主旨: [FI] S.16 Application No. A/YL-KTN/1049 - FI to address departmental comments

1st Further Information

(S.16 Planning Application No. A/YL-KTN/1049)

Responses-to-Comments

DWG. TITLE
FSIs PROPOSAL (1/2)

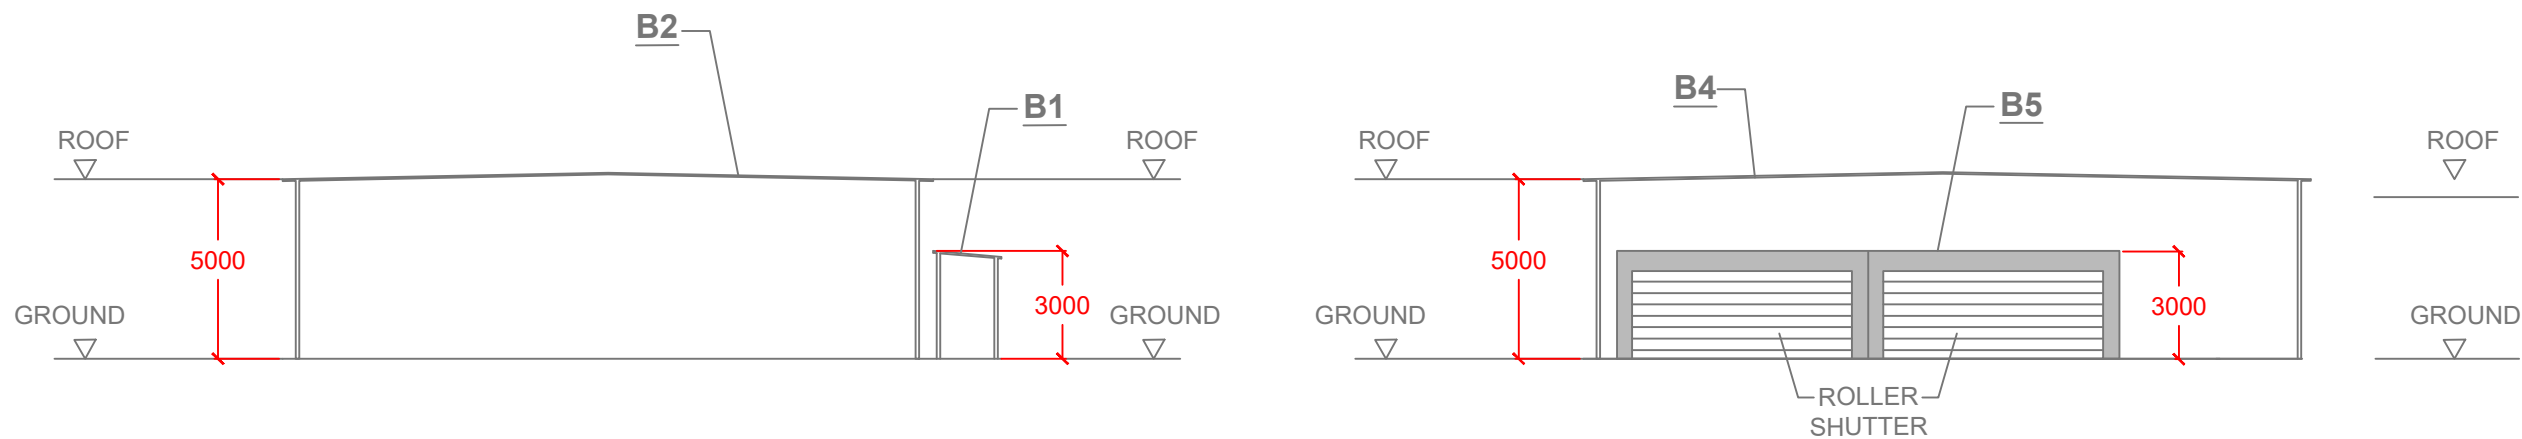
<p>3. Comments of the Director of Fire Services (D of FS) (Contact Person: Mr. CHUNG Wing-hei; Tel.: 2733 7737)</p>		
(a)	<p>With regard to the submitted FSI proposal, he has the following comments:</p> <p>(i) The floor area of structures B5 and B8 shall be indicated on plan; and</p> <p>(ii) Legend of all FSIs shall be provided.</p>	<p>Please refer to the revised fire service installations (FSIs) proposal (Annex II).</p> <p>The floor area of structure B5 and B8 are indicated.</p> <p>The legends of all FSIs are provided.</p>
